# FONSI ATTACHMENT E

## **FINAL EA Appendix G: Additional Coordination Errata**

<b>PROJECT</b> <b>United States National Arboretum Elevated Canopy Trail</b> 3501 New York Avenue, NE Washington, DC	<b>NCPC FILE NUMBER</b> 8538
<b>SUBMITTED BY</b> United States Department of Agriculture National Arboretum	<b>NCPC MAP FILE NUMBER</b> 43.20(70.00)45815
<b>REVIEW AUTHORITY</b> Federal Projects in the District per 40 U.S.C. § 8722(b)(1) and (d)	<b>APPLICANT'S REQUEST</b> Approval of preliminary site and building plans
	<b>ACTION TAKEN</b> Approved preliminary site and building plans with comments

## CANOPY TRAIL PROJECT

TREE HOUSE  
FLOOR PLAN &  
ELEVATIONS

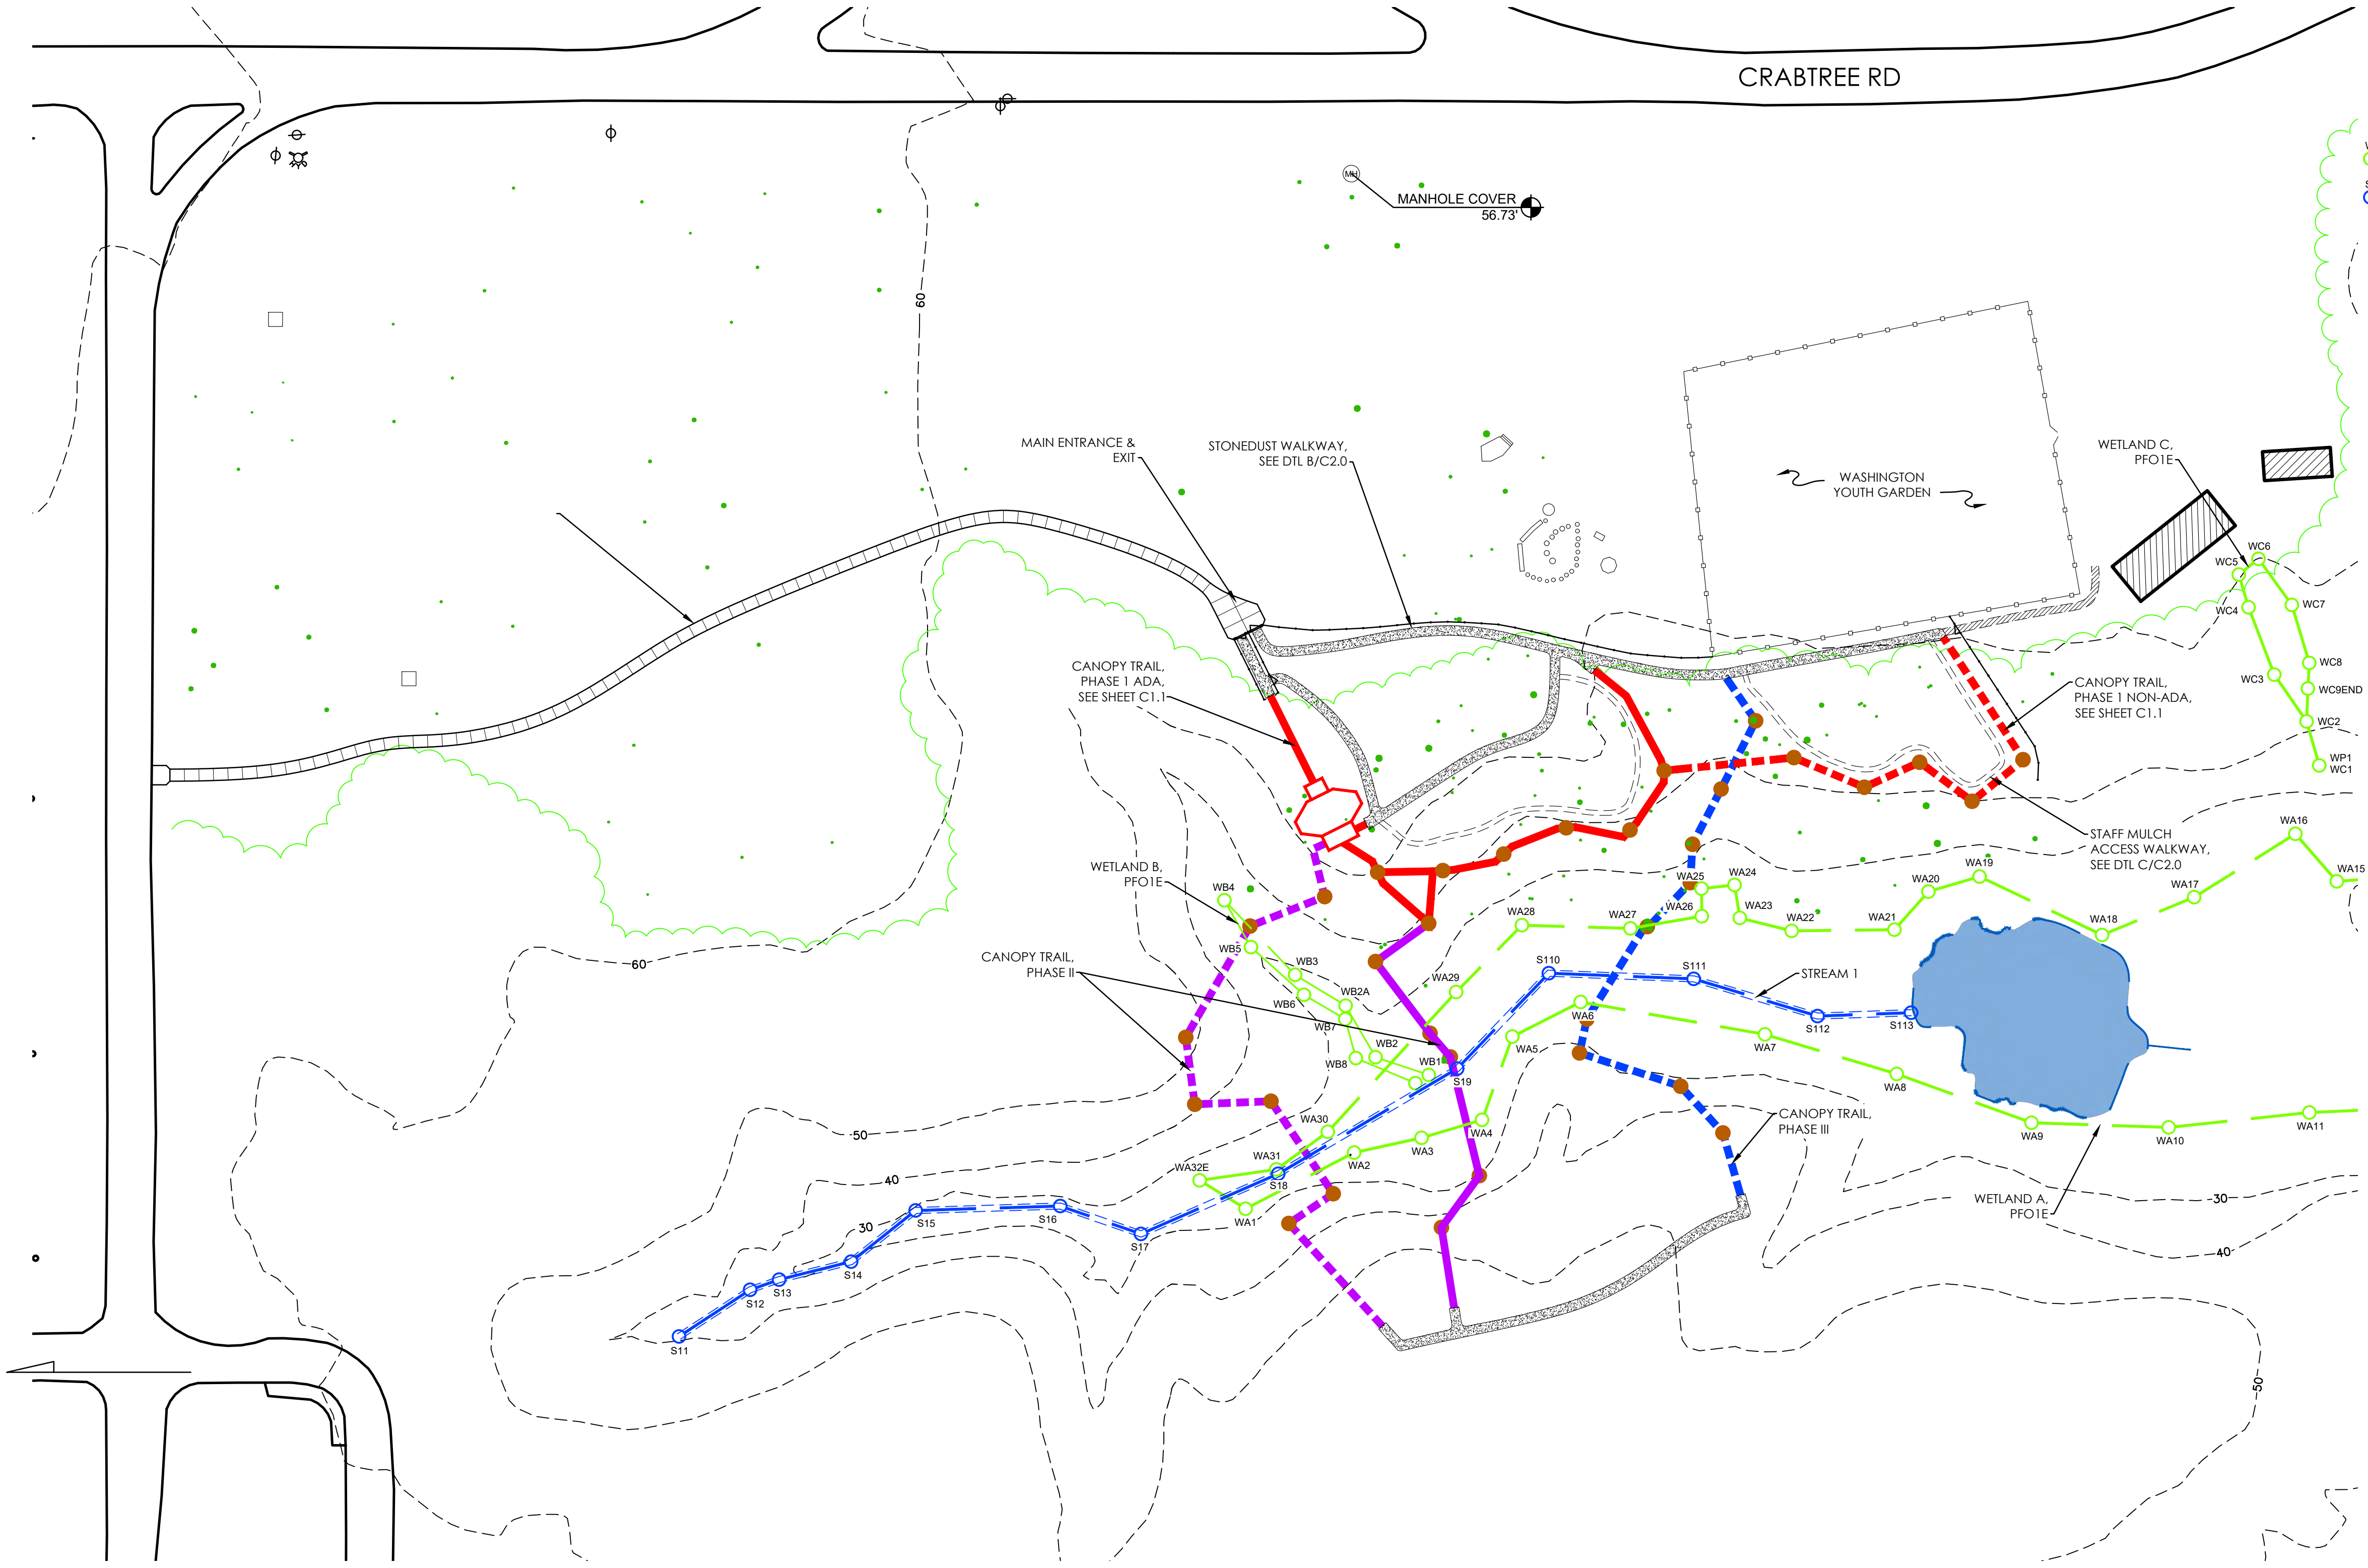
**Recommends** the applicant continue to refine the entry building to help it further blend into the woodland setting, while meeting programmatic requirements.
